San Gabriel Valley Superfund Sites / Baldwin Park Operable Unit

U.S. Environmental Protection Agency • Region 9 • San Francisco, CA • May 1999

EPA Updates Cleanup Plan for the Azusa-Irwindale-Baldwin Park Area

Figure 3: Approximate extent of perchlorate, NDMA and 1,4-dioxane contamination in groundwater

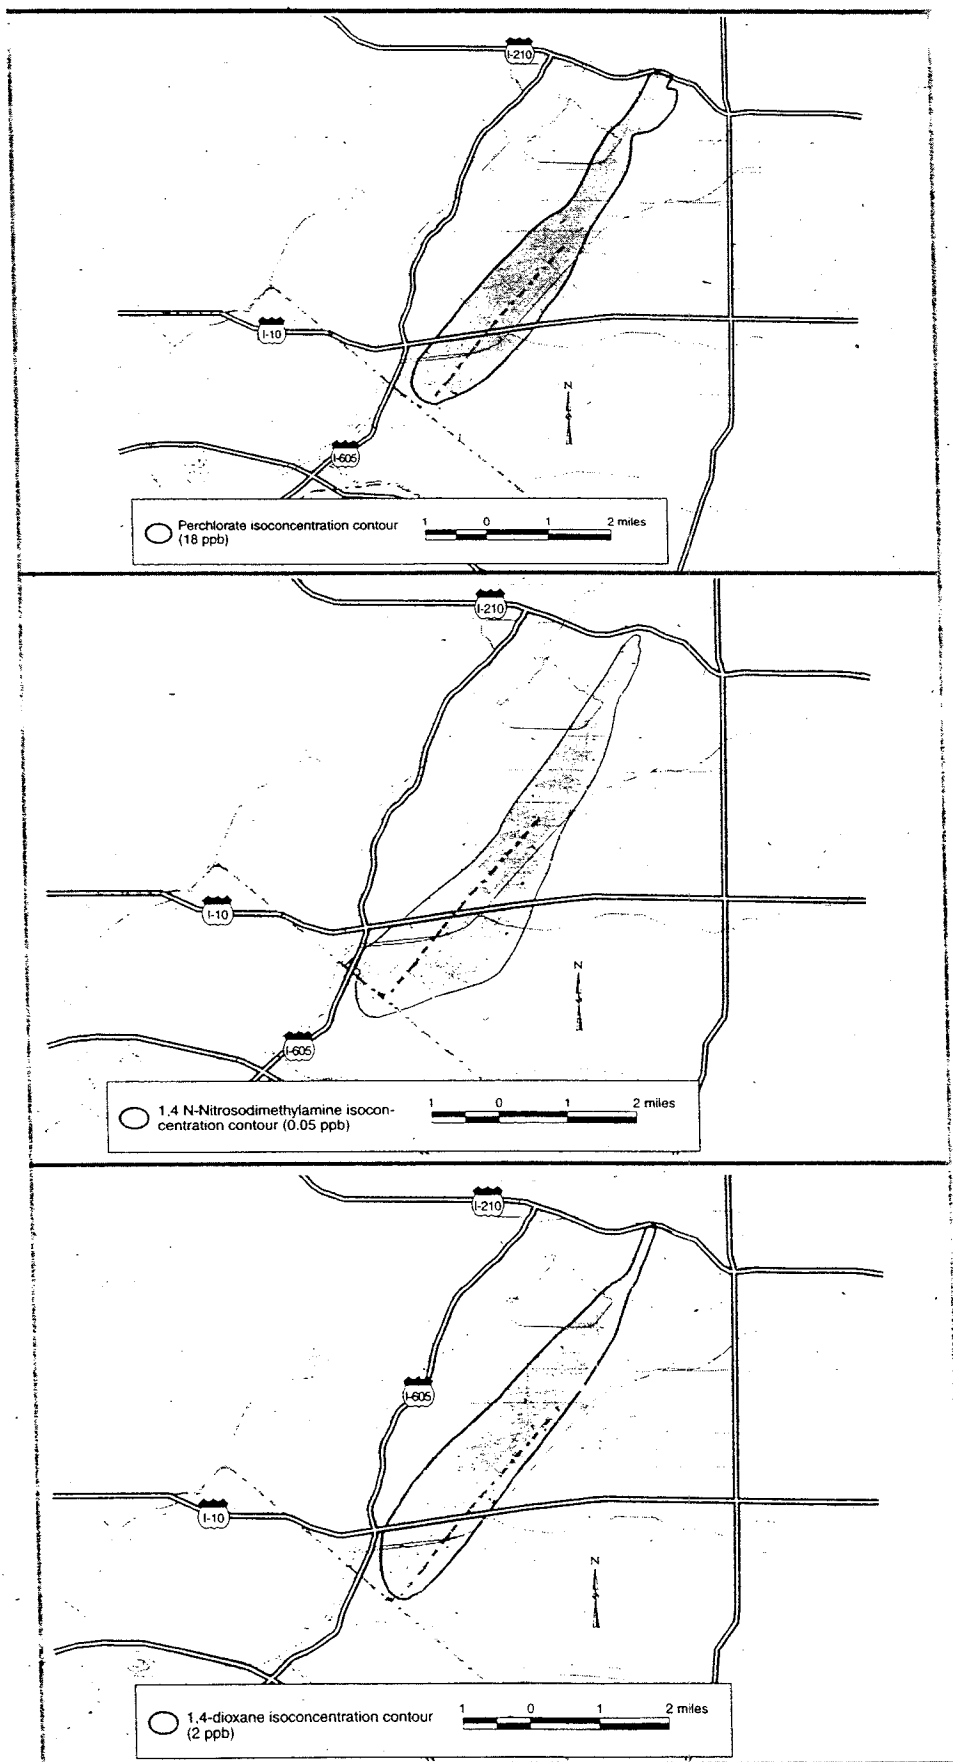
The highest concentrations of perchlorate, NDMA, and 1,4-dioxane are found in the groundwater in Azusa, in Subarea 1. Maximum concentrations of perchlorate and NDMA are more than 100 times the State drinking water action levels of 18 and 0.002 ppb respectively. The maximum concentration of 1,4-dioxane is more than 20 times the State drinking water action level of 3 ppb. Up to six miles downgradient of the industrial source area in Azusa, at the likely groundwater extraction locations in Subarea 3, perchlorate and NDMA concentrations remain above State action levels. The concentration of 1,4-dioxane in this area has, to date, been below the State action level. Figure 3 depicts the approximate extent of perchlorate, NDMA and 1,4-dioxane contamination in groundwater in the Baldwin Park OU.

Figure 4: Groundwater treatment technologies

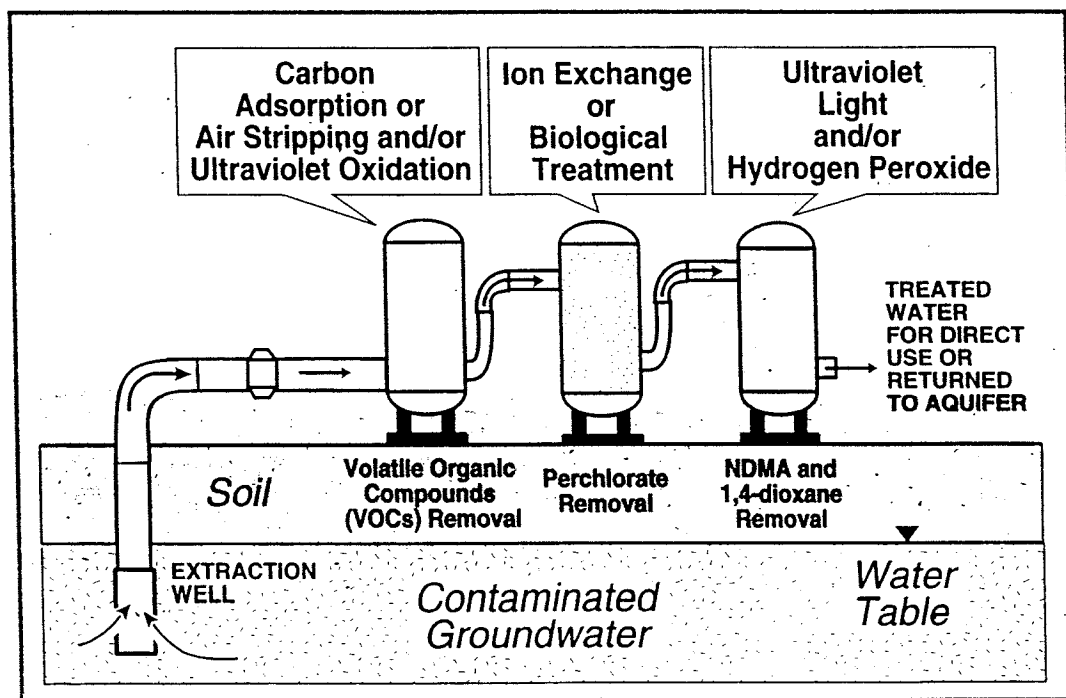
reactor, followed by a biologically-active multimedia filter and granular activated carbon (GAC) *polishing treatment* (see Figure 4). The system will also include ultraviolet light treatment for removal of NDMA and VOCs. Biological treatment methods are new to many water utilities, but *biologically active* filters have been used in drinking water treatment
